SOILS EVALUATION

Record Number: [EHU-07-25-0693](#)

Project Parcel: 411840113

This soils evaluation is intended for Large Lot subdivision China Garden View Estates.
The proposed lot number is 33 of 45.

Preston Enterprises LLC Parcel Number: 411840113 Kalama, Washington 98625	Advanced Septic Consulting Inc. 3210 Westside Hwy. Castle Rock, Washington 98611 Cell: 360-433-5476 E-Mail: dirtwhisperer@gmail.com	Design: 25-151.33	Date: 7/9/2025
		Drawing: 1	Scale: 1" = 40'

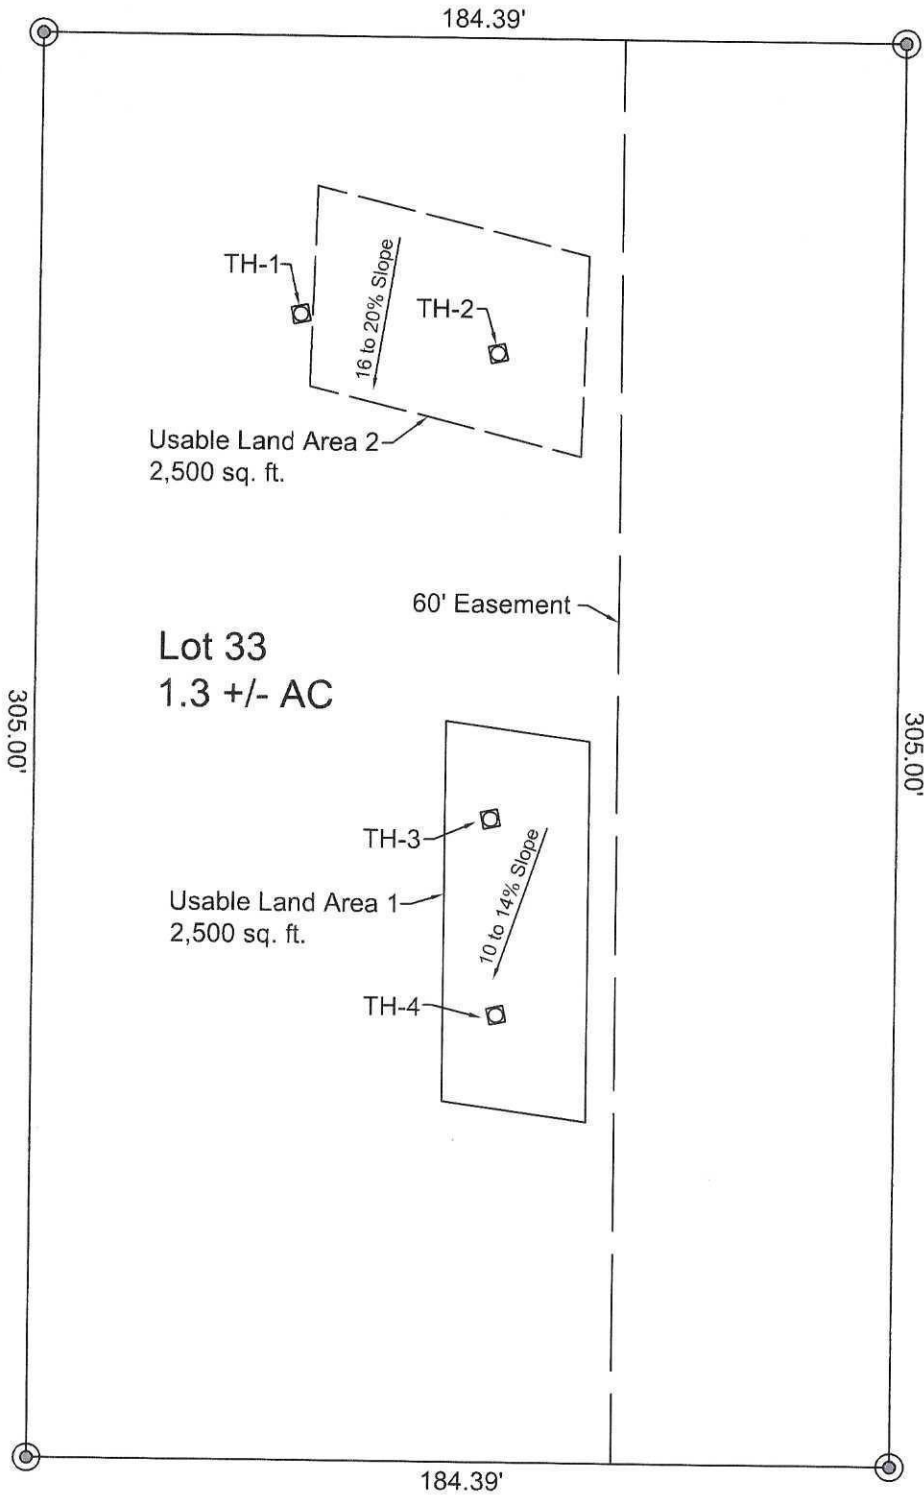
Please Note: A curtain drain will be required around the septic areas.
